APPLICATION NO.	FILING DATE	FIRST NAMED INVENTOR	ATTORNEY DOCKET NO.	CONFIRMATION NO.
09/982,928	10/22/2001	Steven M. Knowles	10765-015001	8524

Office Action Summary

DETAILED ACTION

FIG. 8
Prior Art

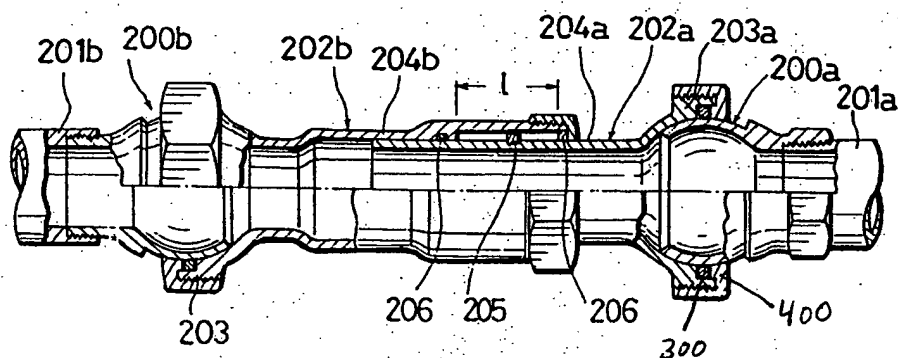
Regarding claims 1, 11 and 12, Sato discloses (figs.8 and 9) a flexible joint assembly for conducting a fluid, comprising: a joint assembly inlet (201a); a joint assembly outlet (201b); and a fluid flow path between the inlet and the outlet, the fluid flow path including: a first pivot joint (200a); a second pivot joint (200b); and a central fluid conductor (202a, 202b) fluidly coupling the pivot joints, wherein the pivot joints together appear to be capable of providing greater than 60° bend between the inlet and the outlet. Sato does not explicitly disclose that the pivot joints together provide greater than a 60° bend; however, a greater than 60° bend is within the scope of Sato’s disclosure. Further, applicant is reminded that it has generally been recognized that the

As to claim 3, Sato discloses the flexible joint assembly of claim 2 wherein each ball and socket joint comprises: a socket (300); a ball (200a) received in the socket; and a seal (300) between the ball to the socket.

As to claim 4, Sato discloses the flexible joint assembly of claim 3 wherein each ball and socket joint further comprises a compressing member (400) axially compressing the seal between the ball and the socket.

As to claim 15, Sato discloses the flexible joint assembly of claim 14 wherein each supporting member comprises an annular support (portion of 400 in contact with seal 300) having a second surface configured to mate with the first surface of the annular seal thereby supporting the annular seal substantially uniformly.

As to claims 16 and 17, Sato discloses the flexible joint assembly of claim 13 wherein: each receiving member comprises a first engagement surface (thread containing surface of 203a); and each supporting member comprises a second engagement surface (thread containing surface of 400), wherein the first engagement surface is configured to engage the second engagement

As to claim 21, Sato discloses a flexible joint assembly comprising: a joint assembly inlet (201a); a joint assembly outlet (201b); and a fluid flow path between the inlet and the outlet, the fluid flow path including: a first pivot joint (200a) configured to pivot about a first pivot (center of 200a); a second pivot joint (200b) configured to pivot about a second pivot (center of 200b); and a central fluid conductor (202a, 202b) fluidly coupling the first pivot joint and the second pivot joint, each of the first pivot joint and the second pivot joint including: an inner member

(ball portion of 200a, 200b) having a dimension in a direction substantially normal to a path through the respective of the joint assembly inlet and outlet; a receiving member (203a, 203b) dimensioned to receive at least part of the inner member; and a sealing member (300) sealing the inner member to the receiving member.
